SWAN Rub and Buzz Improvement – FXN side

First Update

2020.12.14

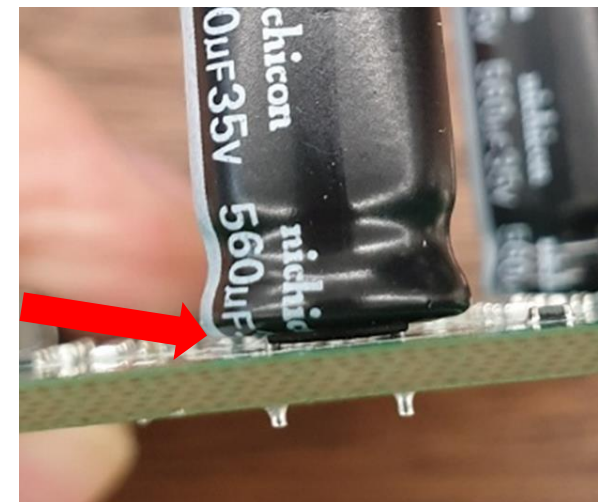
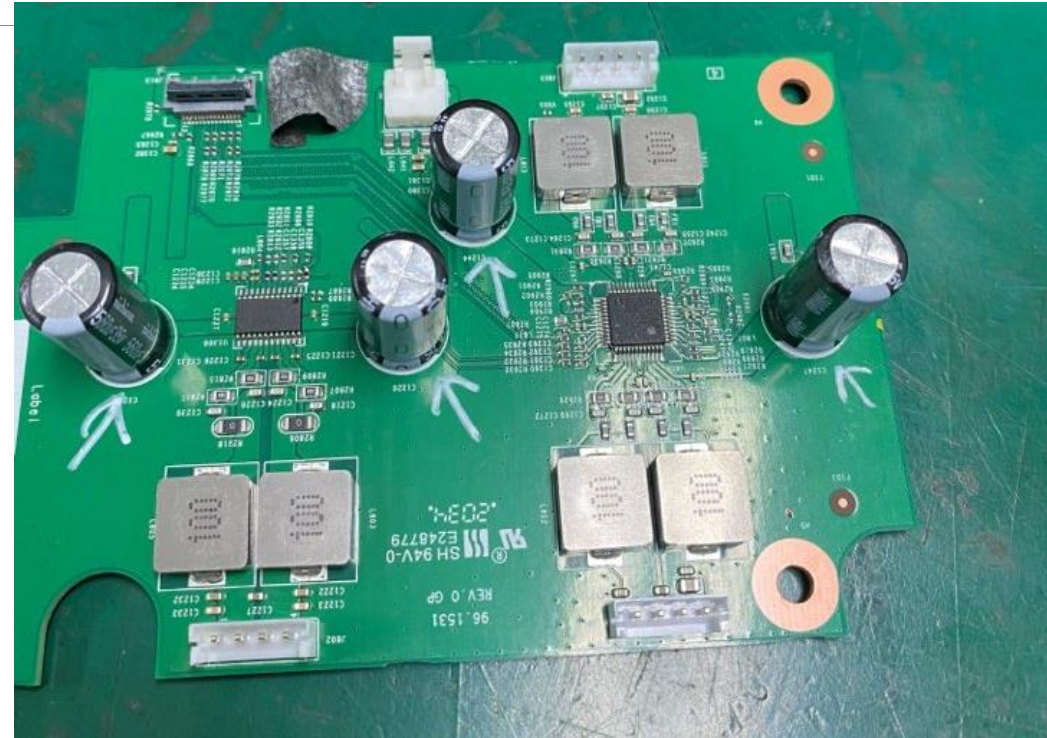
The elec cap need to applied bonding.

: This is make 350Hz band Rub and Buzz noise.

- The elecap is not completely tight to PCB.
- due to Sound vibration is shaking the electric cap.

: Apply silicon between PCB and all of Elecap (4 point)

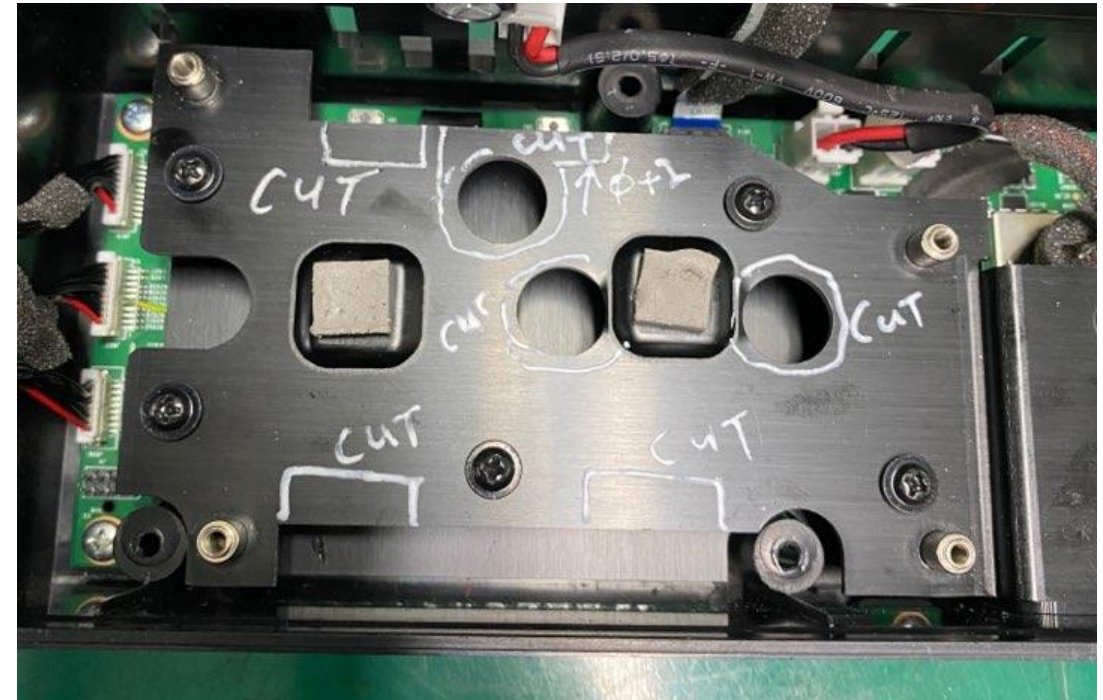
Heat spreader is also make Rub and Buzz noise.

: Amp PCBA and Heat spreader amp bottom is to create noise.

: Cutting area adding and expanding

Add Cutting area : 4 point

**Expanding cutting area :
3 point, +1 pi**
